MODIFICATION #2  
WEST LILAC ROAD OVER I-15 BRIDGE  
DEPARTMENT OF PUBLIC WORKS

**Request for a  
Modification to a Road Standard  
and/or to Project Conditions**

Project Number: TM 5571/5572 Date of Request: Sep. 12, 2012

## LILAC HILLS RANCH: 2.2C LIGHT COLLECTOR MODIFICATION TO ROAD STANDARDS

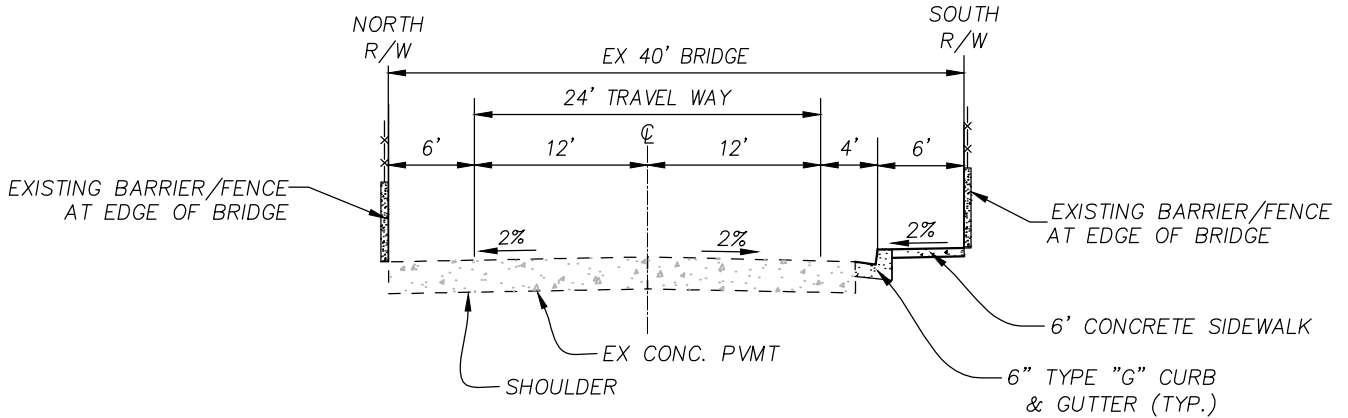
The standard road section for Light Collector Road 2.2C is 40'-54' wide curb to curb  
width on 64'-78' r/w with a minimum design speed of 40 mph. The requested modification  
to the road standard is to require no widening of the existing 40' wide West lilac Road  
bridge over I-15 and allow only re-striping and the addition of curb, gutter and sidewalk  
on one side of the road (see attachment 1).

The existing 40' wide bridge section has a 24' travel way with 8' shoulders on each  
side. A proposed widening of the bridge would be extremely expensive, extremely  
disruptive to anyone that uses West Lilac Road & I-15, and would alter the beauty and  
historic nature of the bridge (see attachment 2). The modified road would also allow  
for safer pedestrian traffic over the bridge.
